EUROPEAN TECHNICAL CENTER
FIRMWARE RELEASE NOTE

DS-KB8112-IM Vandal-Resistant Door Station

V1.4.5_Build_180115 Release Notes

Device Model: DS-KB8112-IM	Firmware Version: V1.4.5_Build_180115
	Client version V2.7.0.6 build 20171212

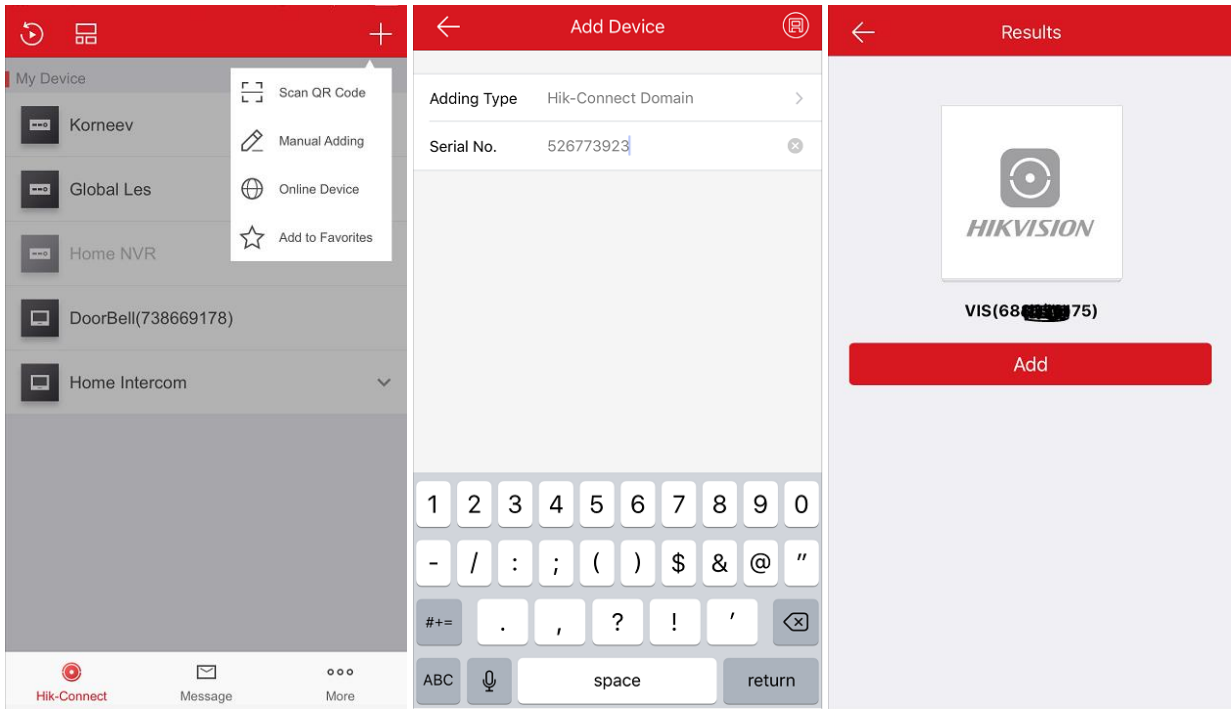
2. Direct connection with Hik-Connect app - Now it is possible to add DS-KB8112-IM to the app where users can have incoming call push notifications, do two-way audio conversation, unlock the door etc.

Using the **Manual Adding** function input the serial number of the device and the verification code ABCDEF. When added successfully, the call will be pushed to the app directly, without calling the SIP phone or IVMS-4200 even if they are configured.

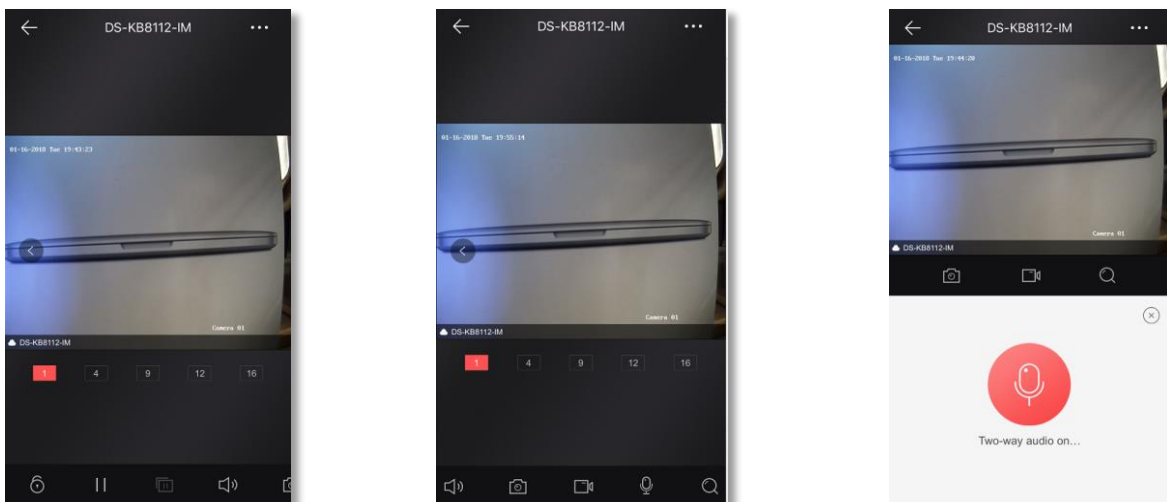
3. Added 2-way audio button in Live view Mode – users can initiate a 2-way audio talk without waiting for visitor to call

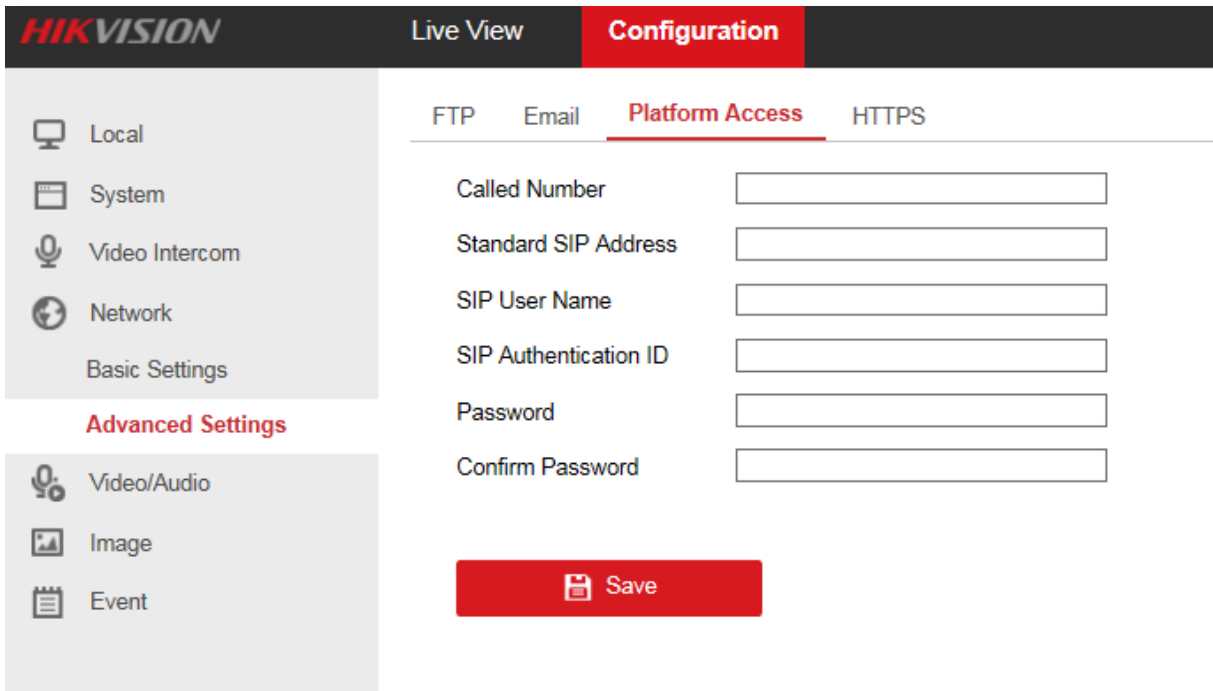
4. **Make calls to standard SIP compatible devices with audio and video** – this is a very basic initial implementation of standard SIP that can be used only for calls within the local network.

Type device IP address in an internet browser and to get into web configuration. Then go to: Network → Advanced Setting → Platform Access and set the SIP parameters.

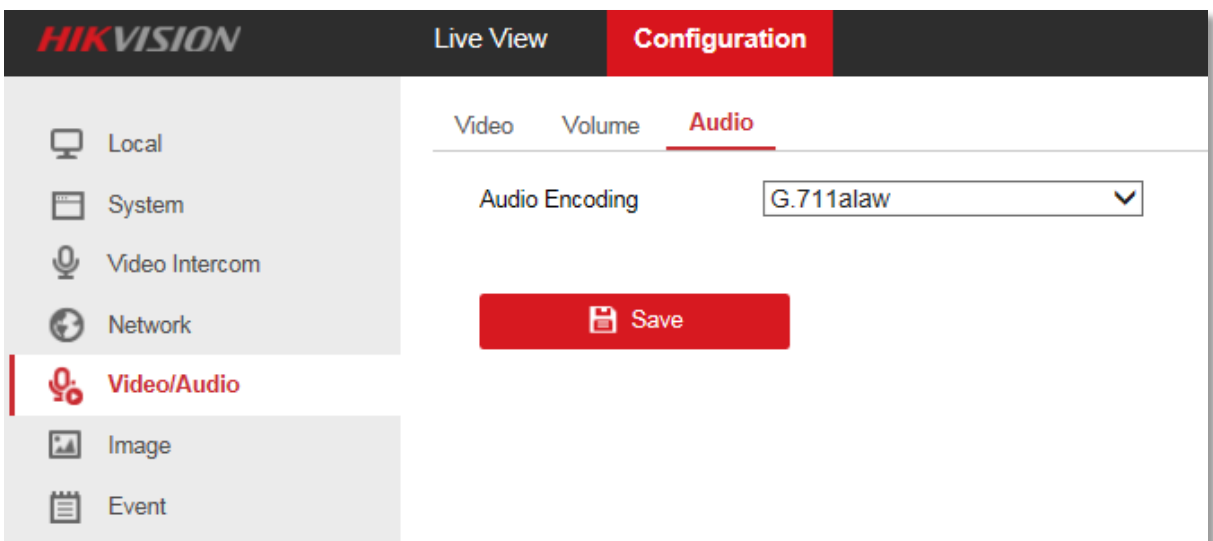
If the established audio communication between the device and IVMS4200/SIP phone/App is not good, go into audio settings and change the audio coding to G.711alaw.
